**ADDENDUM No. 1 (April 17, 2023)**

ADDENDUM TO: Seating Bowl Glass Railing Replacement Project, RJS

BID NUMBER: 22-05

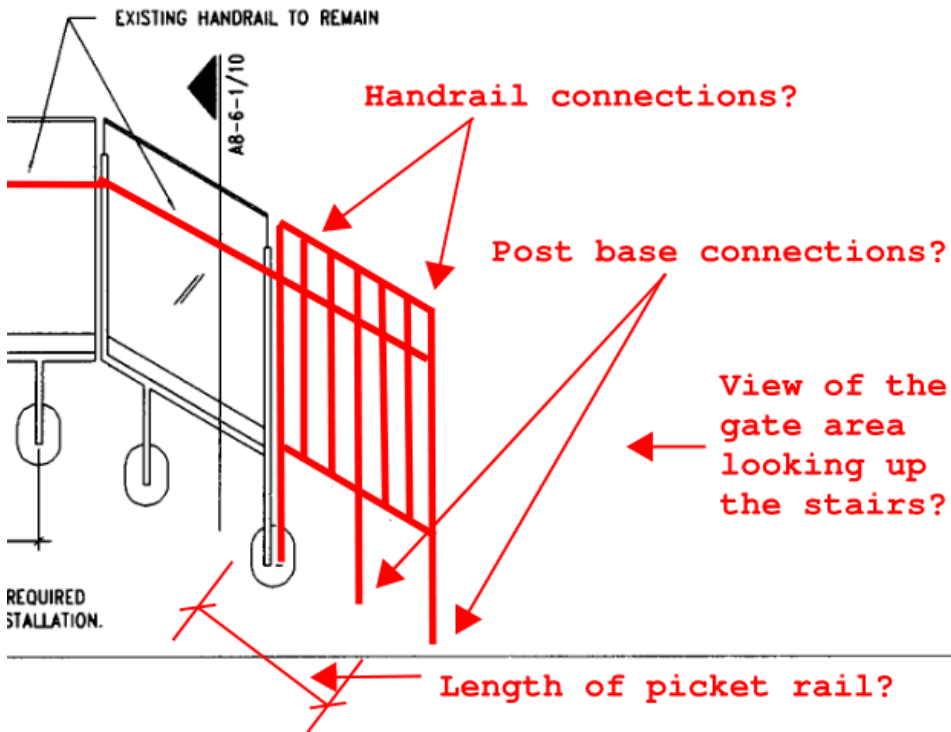
One of the major challenges is the fascia base plate shared by both the glass rail and the pickets. When the old glass rail is removed ... the remaining shared fascia plate will be damaged. Any reuse (or patch) of this plate will be far less attractive than what we believe your stadium deserves.

We also have concerns with the structural integrity and engineering approvals. There could be complications using the existing anchor holes. Drilling new holes would be preferred ... but that opens the potential of hitting post cables or reinforcement. For these reasons we are moving quickly to secure preliminary structural calculations.

Could you please send a few more pics showing the full bottom condition of the lower stairs? The pictures in this email only show the top of the picket rail, but not how they are attached at the bottom. They also don't show the connection of the handrail climbing the stairs. Unfortunately, I also didn't include a picture of the gate that opens into the stairs.

The below snippet will outline the info we are looking for.

**TSA RESPONSE:** Photos attached.

**TSA RESPONSE:** Related to their question on the condition where the glass handrail section attaches to the same baseplate as the steel handrail (scheduled to remain), I think we are open to options that they would like to propose. Depending on what material they choose to use for the new rails this may affect this. New galvanized steel rails could be welded to this existing base plate like the existing condition assuming that their structural calculations work out. This existing base plate can also be left in place (with the existing glass rail support removed and ground smooth) for just the existing railing section. A new separate baseplate next to it could then be provided for the new rail section. Again, we are open to several different solutions as long as they meet the load capacity.
